RENESAS TECHNICAL UPDATE

Product Category	MPU/MCU		Document No.	TN-RZ*-A0079B/E	Rev.	2.00
Title	RZ/G2H, RZ/G2M V1.3, RZ/G2M V3.0, RZ/G2N and RZ/G2E Additional explanation for Electrical Characteristics		Information Category	Technical Notification		
Applicable Product	RZ/G Series, 2nd Generation RZ/G2H, G2M V1.3, G2M V3.0, G2N and G2E	Lot No.	Reference Document	RZ/G Series, 2nd Generation User's Manual: Hardware Rev.1.01 (R01UH0808EJ0101)		
		All lots

Additional explanation for "Hardware Electrical Characteristics Common to RZ/G Series, 2nd Generation products".

Figure 73.3.1.1 PRESET# VS. Power [RZ/G2H] [RZ/G2M V1.3] [RZ/G2M V3.0] [RZ/G2N]

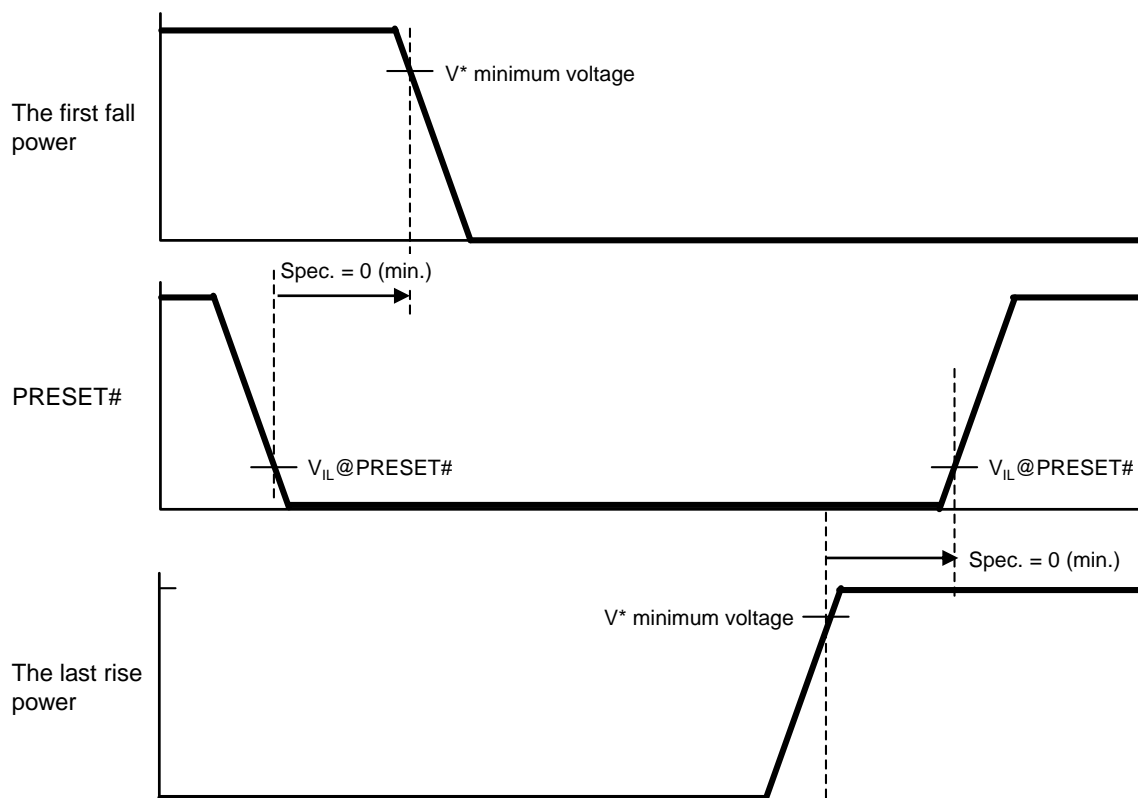
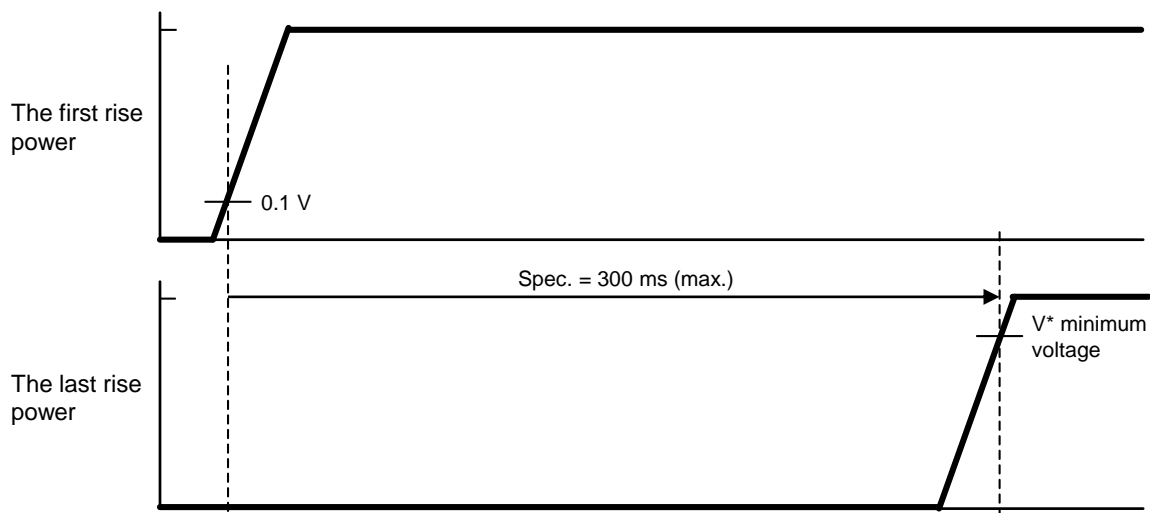
- Section 73.3 Sequence of Tuning On/Off Power Supplies, Page 73-10, 73.3.1 Sequence of Turning On/Off Power Supplies for [RZ/G2H] [RZ/G2M V1.3] [RZ/G2M V3.0] [RZ/G2N]. (1) PRESET# VS. Power

Added figure number and figure title.

Note that at power-on reset, refer to the specifications shown in section 73.5 "Clock and Reset Timings".

Figure 73.3.1.2 Period for Power Rise for [RZ/G2H] [RZ/G2M V1.3] [RZ/G2M V3.0] [RZ/G2N]

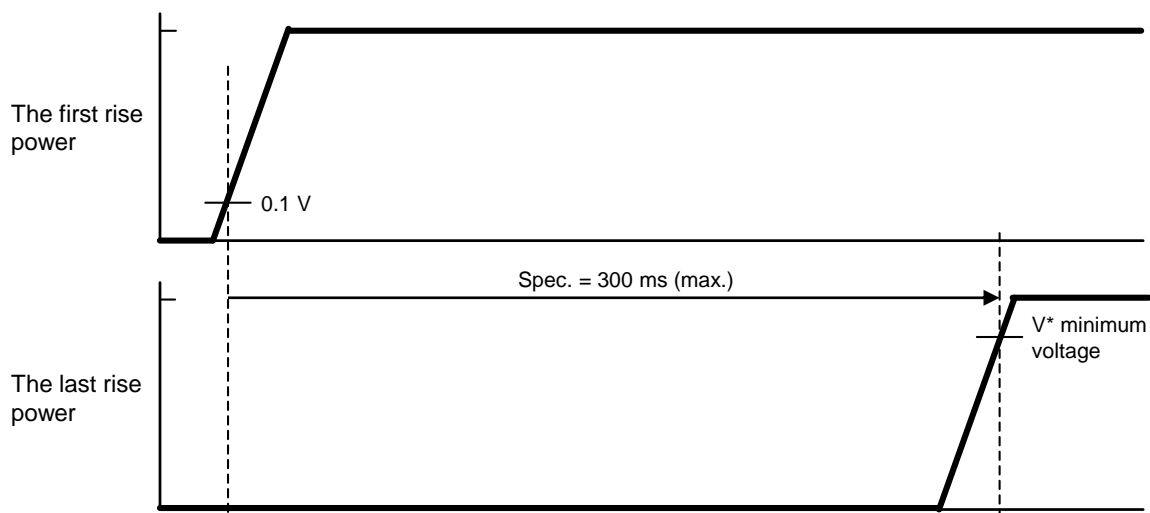
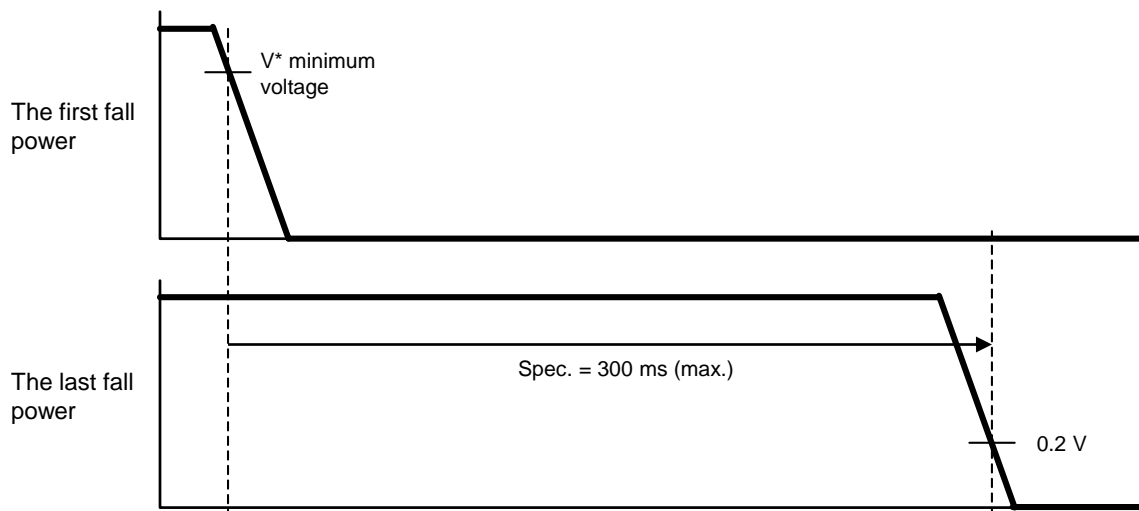
2. Section 73.3 Sequence of Tuning On/Off Power Supplies, Page 73-11, 73.3.1 Sequence of Turning On/Off Power Supplies for [RZ/G2H] [RZ/G2M V1.3] [RZ/G2M V3.0] [RZ/G2N]. (2) Period for Power Rise for RZ/G2H, RZ/G2M V1.3, RZ/G2N

Added figure number and figure title.

For all V*, power off state must be 0 V (GND), power rising must be started from 0 V, and end to 0 V respectively. (excluding DDR-SDRAM power-supply backup state)
 Period from 0 V to 0.1V at power-on and from 0.2 V to 0 V at power-off should be shorten as much as possible.

Figure 73.3.1.3 Period for Power Fall for [RZ/G2H] [RZ/G2M V1.3] [RZ/G2M V3.0] [RZ/G2N]

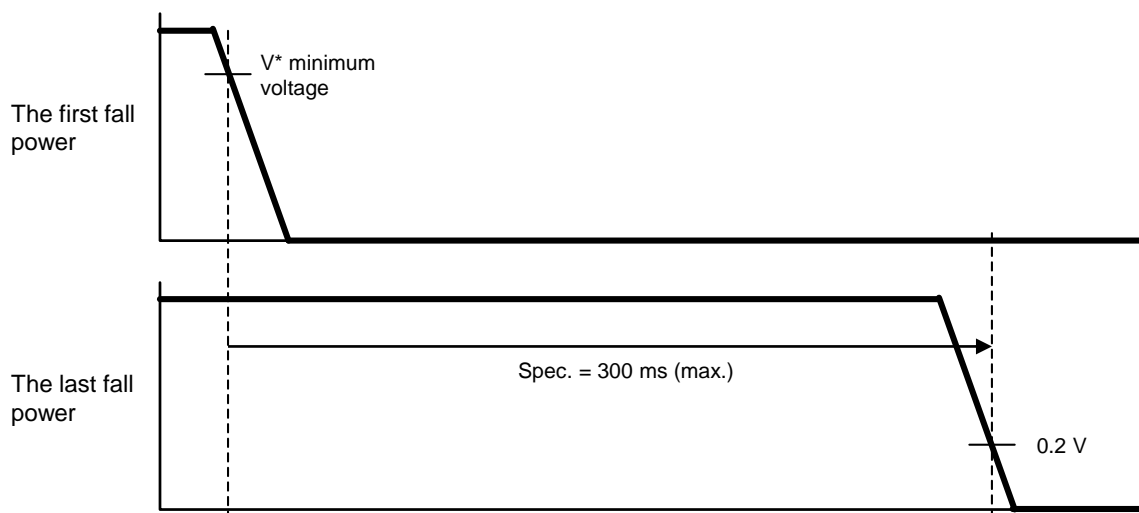
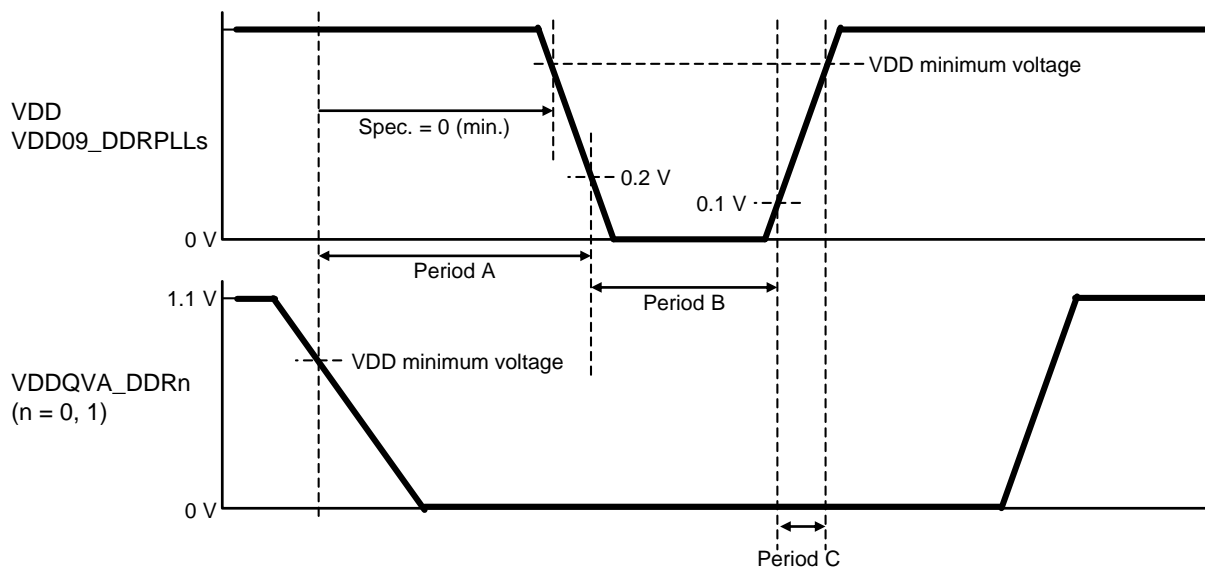
3. Section 73.3 Sequence of Tuning On/Off Power Supplies, Page 73-12, 73.3.1 Sequence of Turning On/Off Power Supplies for [RZ/G2H] [RZ/G2M V1.3] [RZ/G2M V3.0] [RZ/G2N]. (3) Period for Power Fall for RZ/G2H, RZ/G2M V1.3, RZ/G2N

Added figure number and figure title.

For all V*, power off state must be 0 V (GND), power rising must be started from 0 V, and end to 0 V respectively. (excluding DDR-SDRAM power-supply backup state)
 Period from 0 V to 0.1V at power-on and from 0.2 V to 0 V at power-off should be shorten as much as possible.

Figure 73.3.1.4 VDD and VDD09_DDRPLLs vs VDDQVA_DDRn (n = 0, 1)
 [RZ/G2H] [RZ/G2M V1.3] [RZ/G2M V3.0] [RZ/G2N]

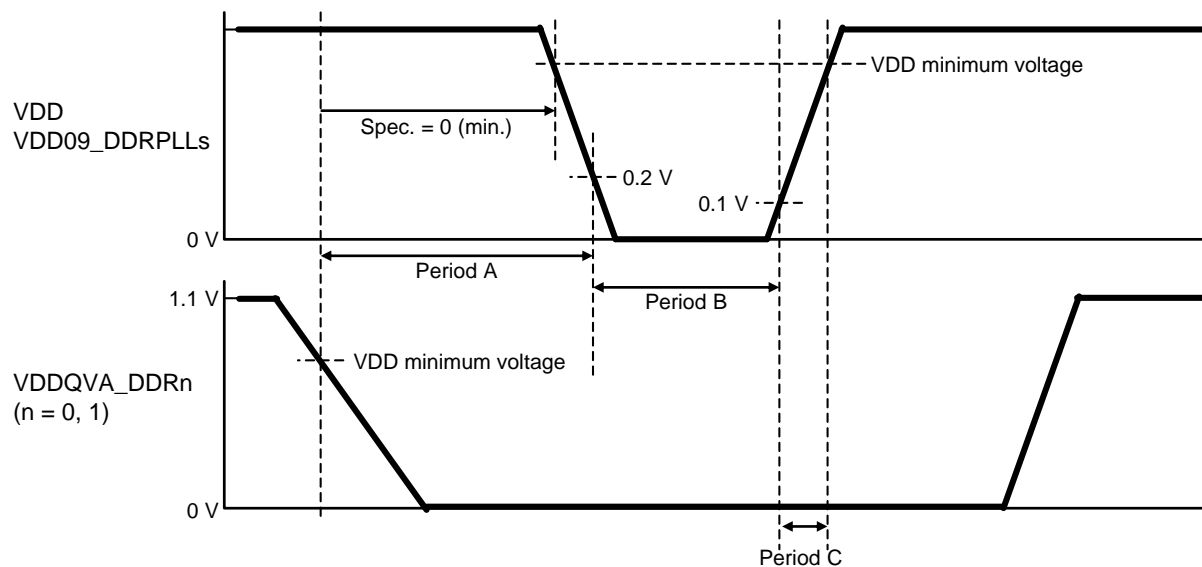
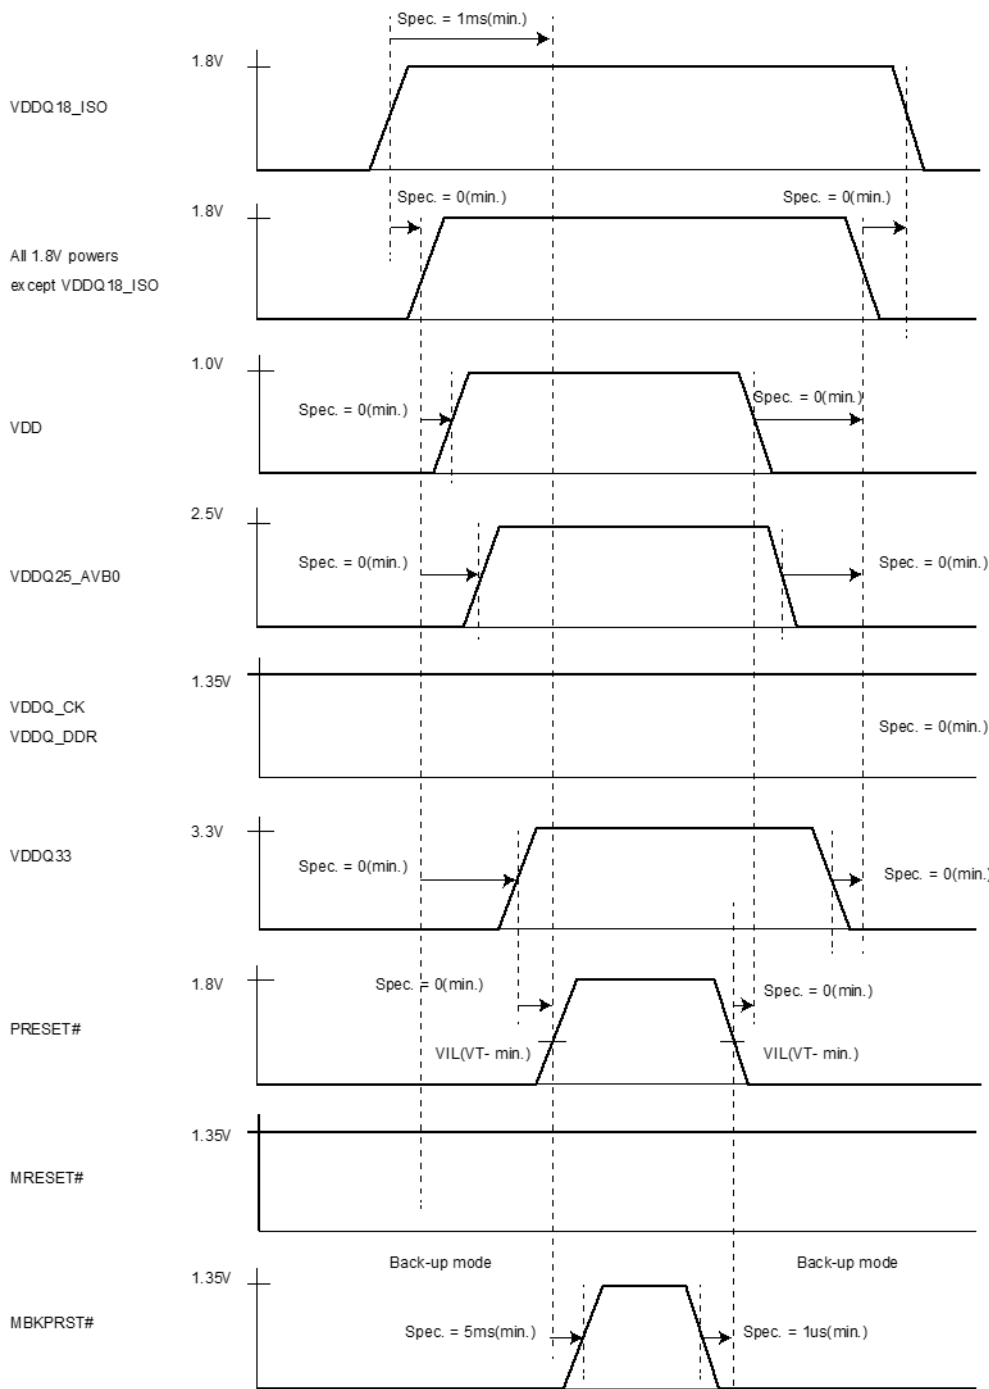
4. Section 73.3 Sequence of Tuning On/Off Power Supplies, Page 73-13, 73.3.1 Sequence of Turning On/Off Power Supplies for [RZ/G2H] [RZ/G2M V1.3] [RZ/G2M V3.0] [RZ/G2N]. (4) VDD and VDD09_DDRPLLs vs VDDQVA_DDRn (n = 0, 1) for RZ/G2H, RZ/G2M V1.3, RZ/G2M V3.0, RZ/G2N

Added figure number and figure title.

VDD and VDD09_DDRPLLs must be greater than VDDQVA_DDRn (n = 0, 1) for Period A.
 VDDQVA_DDRn (n = 0, 1) must be off for Period B.
 VDD and VDD09_DDRPLLs must be greater than VDDQVA_DDRn (n = 0, 1) for Period C.
 VDD09_DDRPLLs are VDD09_DDRPLLnm (n = 0-3, m = CA, DQ01, DQ23)

Figure 73.3.2.1 power-up/down sequence with DDR backup [RZ/G2E]

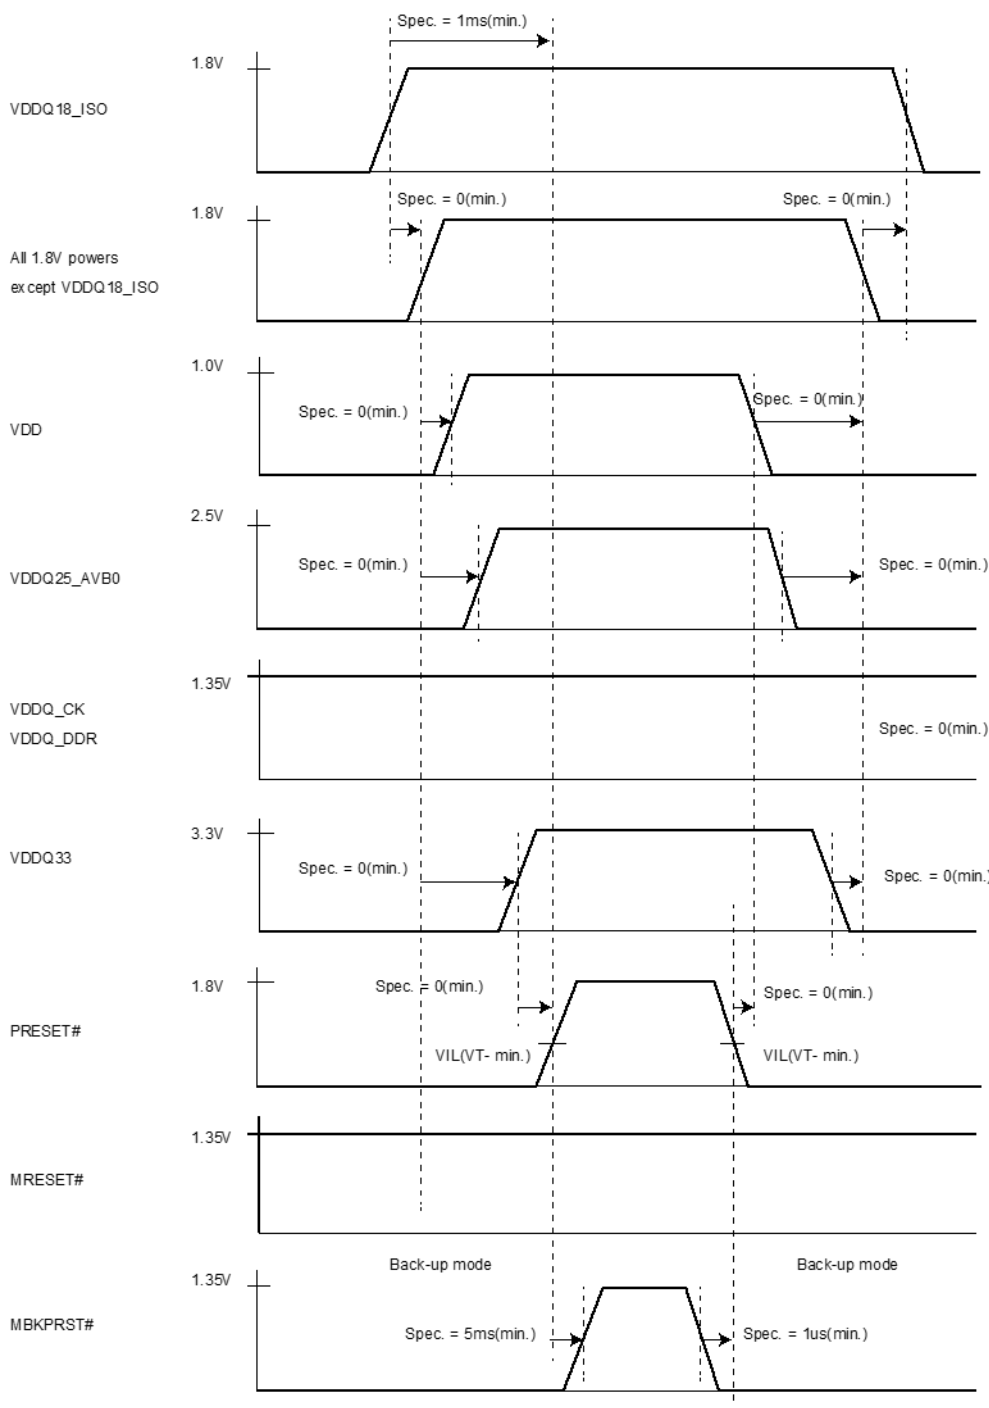
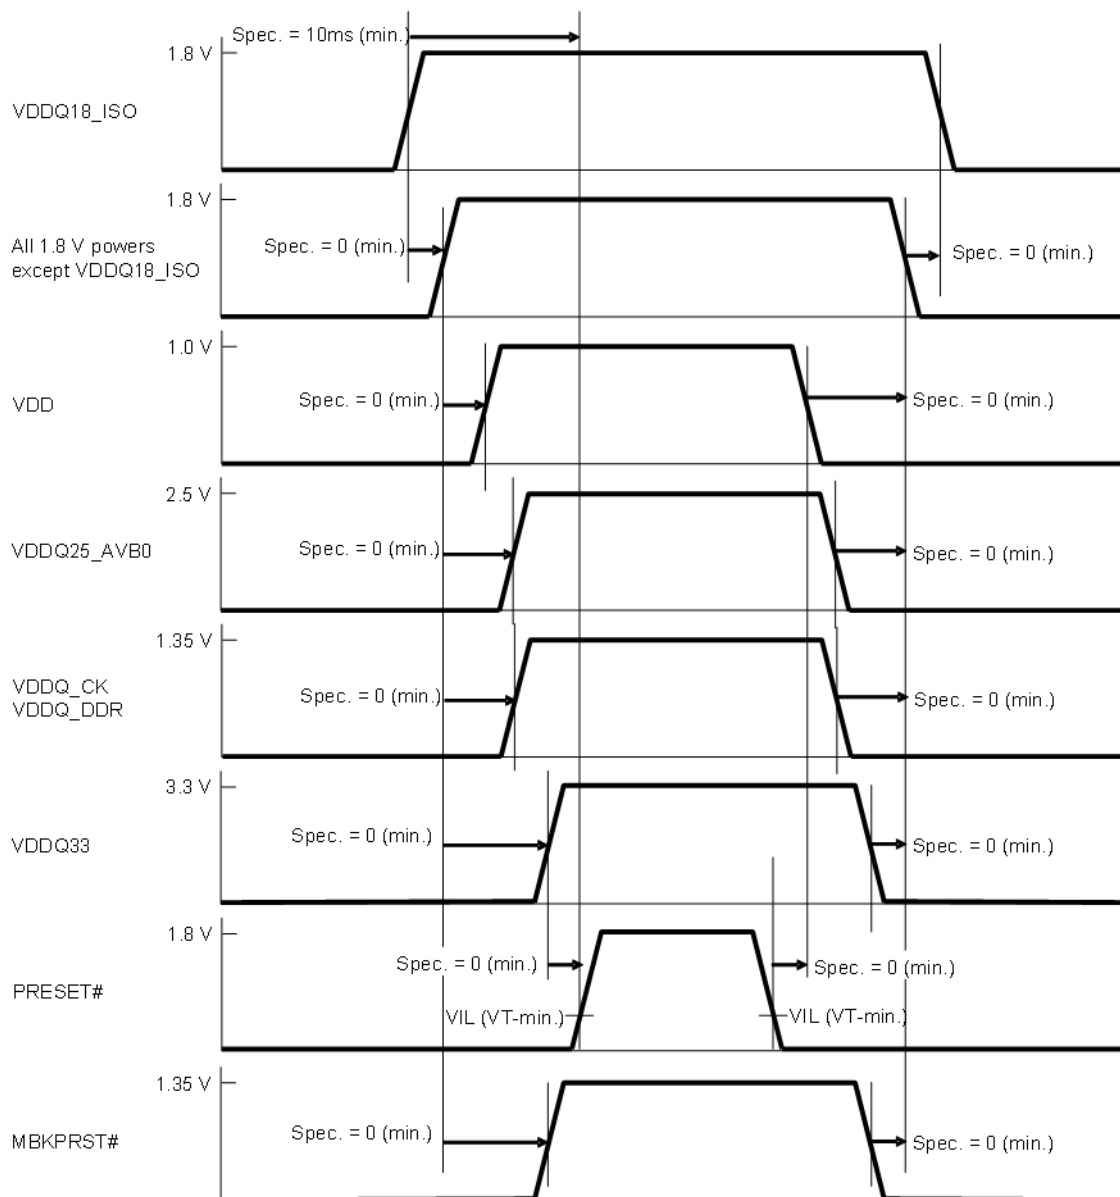
5. 73.3 Sequence of Turning On/Off Power Supplies, Page 73-14, 73.3.2 Sequence of Turning On/Off Power Supplies for [RZ/G2E]. (1) RZ/G2E power-up/down sequence with DDR backup. Notes of Figure are corrected.

Note: Maximum time from first power rising to last power rising is 300ms.
 Maximum time from first power failing to last power failing is 300ms.
 Notes that the MBKPRST# must be asserted for 5 ms or more for the PRESET# tOSC specification at a power-on reset.

Change notes to refer to the section that defines the specification.

Note: Refer to Figure 73.3.4.1 for the maximum time from first power rising(falling) to last power rising(falling). Note that at power-on reset, refer to the specifications shown in section 73.5 "Clock and Reset Timings". Even when DDR backup mode is used, the first power up sequence must keep the sequence "RZ/G2E power-up/down sequence without DDR backup".
